11 Charlotte Street - Zoning Amendment and Site Plan Applications- Request for Direction Report

Date:	August 19, 2011
To:	Toronto and East York Community Council
From:	Director, Community Planning, Toronto and East York District
Wards:	Ward 20 – Trinity-Spadina
Reference Number:	10-317203 STE 20 OZ and 10-317208 STE 20 SA

Attachment 4: Site Plan

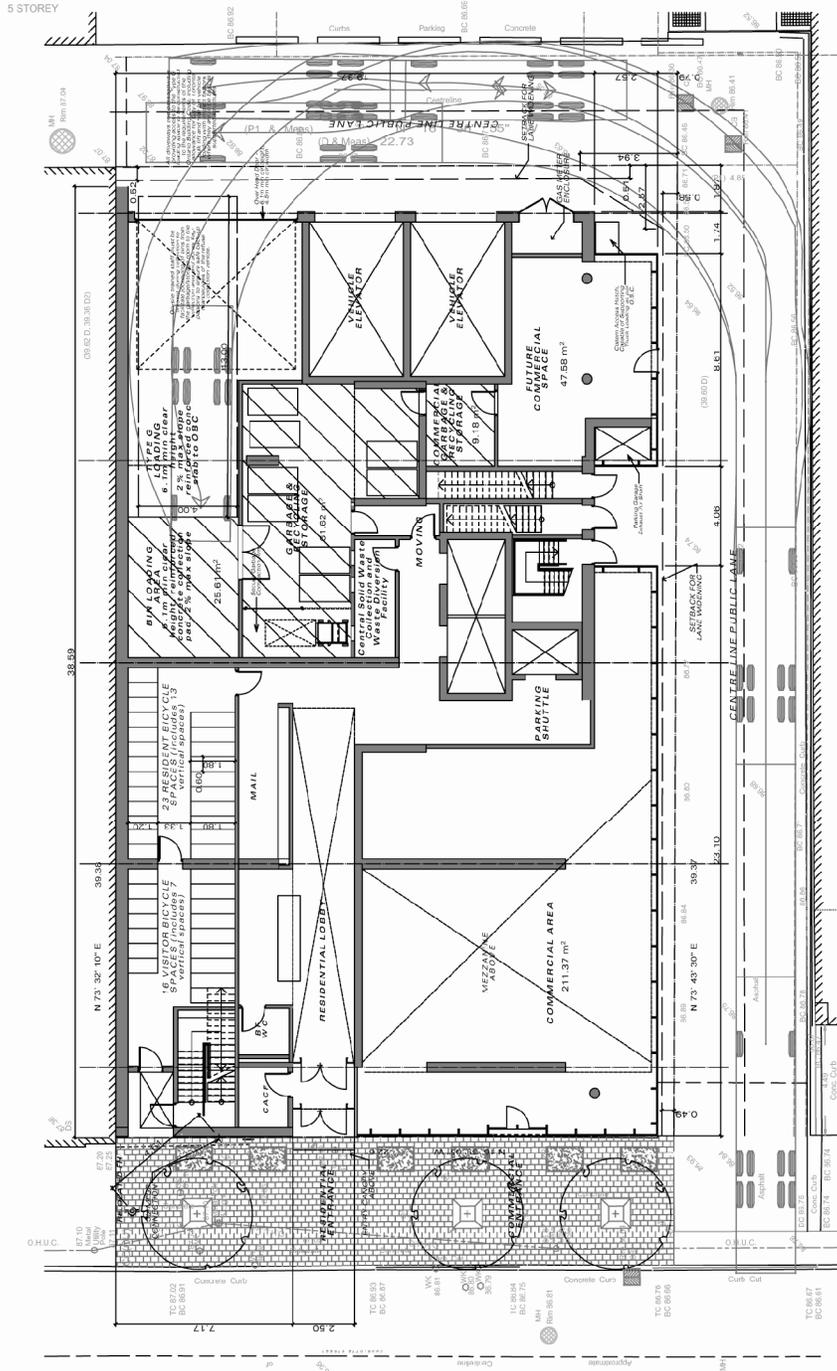
The south side of the building proposes an approximate setback of 0.26 metres from the property line for the tower element from floors 7-32. For the north, east and west setbacks, approximately 5.53 metres, 0.86 metres, and 2.93 metres are proposed, respectively.

The reduced setbacks will negatively impact the properties to the south and east, which have significant development potential under the as-of-right permissions.

In this case, the reduced setback would transport the facing distances and setbacks requirements to adjacent properties. The impacts on the existing properties adjacent to the east, north and south are of particular concern as they have not yet redeveloped and have significant development potential as-of-right. The proposal will negatively impact the ability of these properties to develop in a manner that ensures that adequate light, view and privacy can be provided for people on these properties.

The applicant has revised the ground floor of the proposed building to now include an additional commercial space at the south-east corner of the site, being the confluence of the abutting north-south and east-west laneways. The access to the underground parking garage and loading area has been removed from the east-west laneway and is now located along the east side of the building, adjacent to the north-south laneway. The retail space takes its front door access directly from the laneway. In its current format, space does not allow for adequate width for both vehicle movements and a pedestrian walkway. Careful attention and design consideration, as well as revisions to the building, will need to be assessed to ensure that conflicts between these two users of the laneway will be mitigated, and that conditions will be safe for pedestrian users.

Additionally, parking to the underground will be provided by two car elevators, which as mentioned, is located directly off of the north-south laneway. Staff have reviewed the queuing assessment provided by the consultant and have identified that the assessment does not take into account current activity on the laneway system, nor is there consistency in the measured timing for the vehicles to enter and exit the elevators. These matters, among others identified in staff comments will need to be addressed to the satisfaction of Technical Services staff.

It is recommended that either additional land be acquired, or that a form of easement or agreement be entered into with adjacent landowners in an effort to achieve adequate separation distances to other towers within the Charlotte block.
